SUBJECT: DAVIS-BESSE NUCLEAR POWER STATION, UNIT 1 - ISSUANCE OF AMENDMENT (TAC NO. MB8953)

AMENDMENT TO FACILITY OPERATING LICENSE

SAFETY EVALUATION BY THE OFFICE OF NUCLEAR REACTOR REGULATION

RELATED TO AMENDMENT NO. 257 TO FACILITY OPERATING LICENSE NO. NPF-3

Figure 1. Full Power, High Decay Heat Post LOCA Representative Pressure-Time Histories

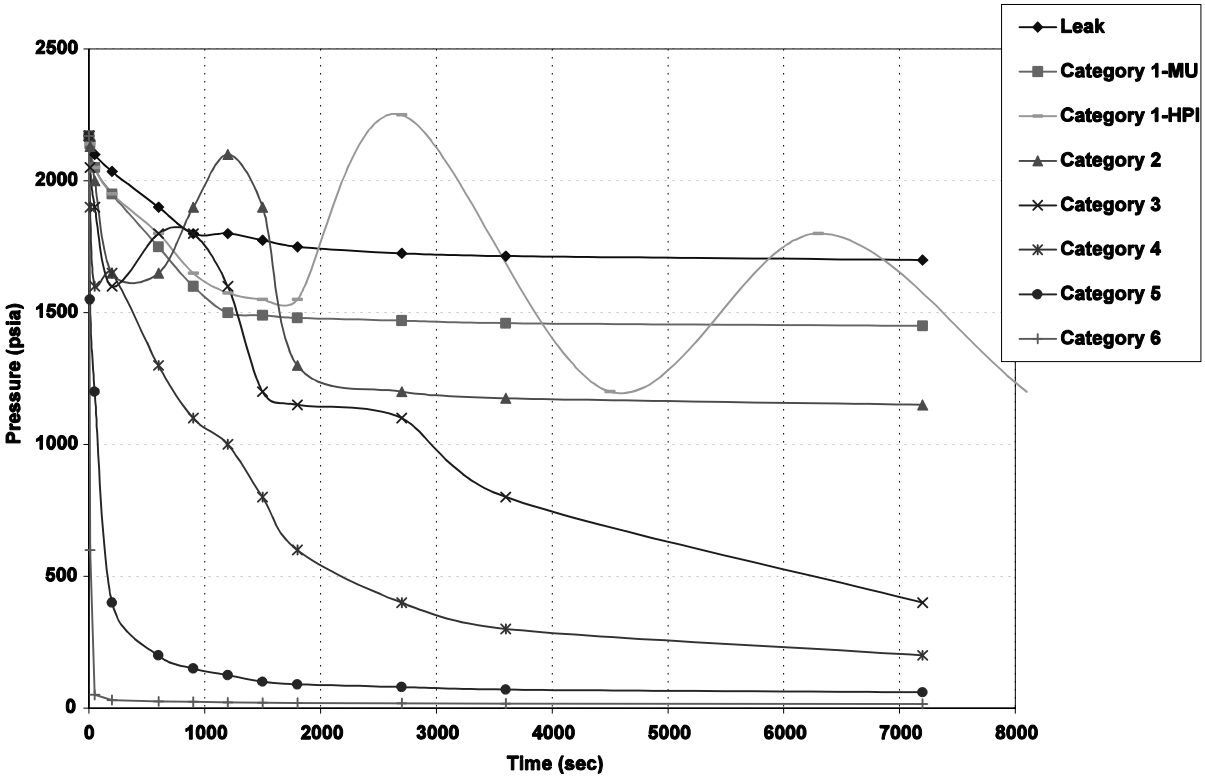
RCS pressure behavior for each of these categories for initiation of the accident during power operation is illustrated in Figure 1.

Figure 1, a leak may be characterized by a small initial decrease in RCS pressure, followed by a steady state condition where injection rate and leak rate are in balance.

Category 5 breaks are sufficiently large to depressurize the RCS to approximately the containment pressure as shown in Figure 1. Cold leg breaks in this Category are not large enough to reverse core flow, which would cause the cladding to exceed the critical heat flux upon break initiation. The core is shut down via control rods and cooled during the blowdown transient, which maintains a two-phase mixture that keeps the fuel pin cladding within a few

Figure 2. Mode 3 Low Decay Heat Post-LOCA Representative Pressure-Time Histories

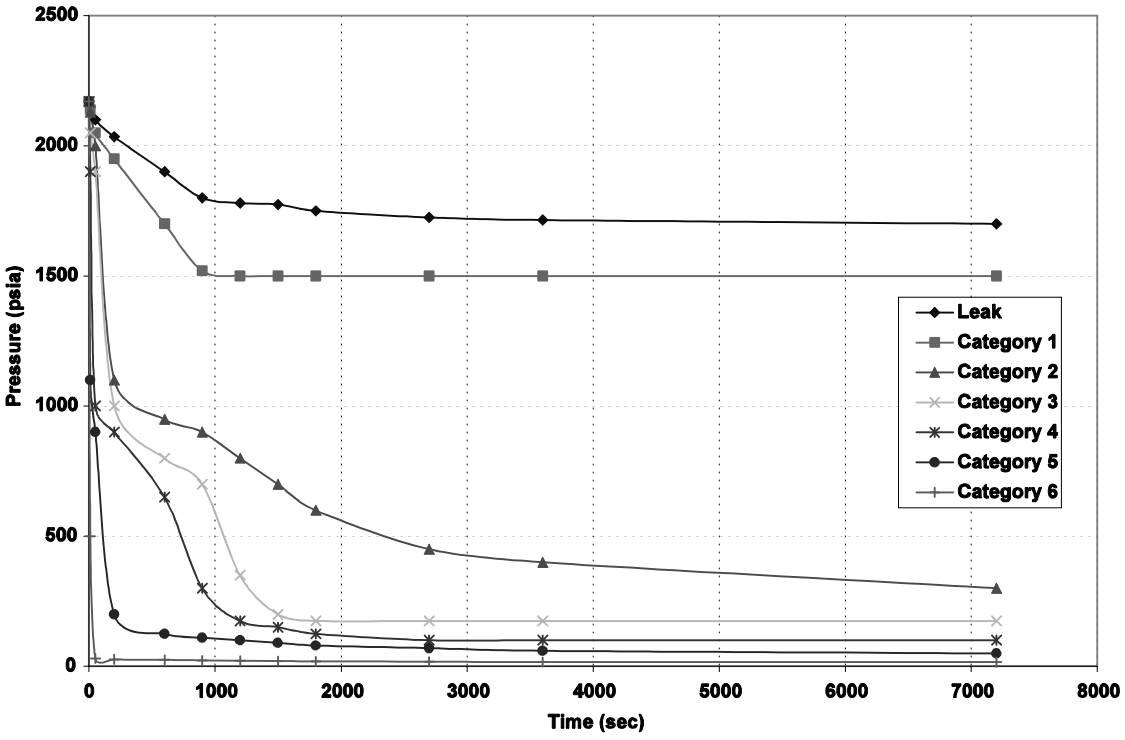
heat generation, the secondary side has no potential to repressurize to the main steam safety valve pressures. Note, however, that if the RCPs are running, RCP heat will require SG heat removal. Typical RCS pressure response for the various break categories is shown in Figure 2.

A leak is successfully managed with operator actions and MU flow as described for the full power analyses. Pressure response to a leak is similar to the response for the full power results in Figure 1. The real differences in the pressure trends are observed for the LOCAs. The Category 1 LOCAs have no potential for RCS repressurization unless the ECCS flow is increased, and the RCS pressure consequently evolves to a pressure at which the ECCS injection matches the break flow. The pressure response will be similar if only HPI is credited or if HPI and MU are both credited. The only difference is, if MU is credited, the quasi-steady RCS pressure trend shown in Figure 2 will be higher for the Category 1 breaks.

Figure 2 shows that some of the smaller LOCAs will remain above the LPI shutoff head for an extended time. Although that is not of concern when long-term HPI operation is ensured, this is not the case for the proposed Mode 3 test conditions. During the proposed test, HPI operability is not ensured after the transfer is made to recirculation flow from the containment emergency sump. Consequently, RCS pressure must be ensured to be below the LPI shutoff head prior to the transfer. Depressurization actions may therefore be necessary that are not considered when the full complement of ECCS pumps is operable.
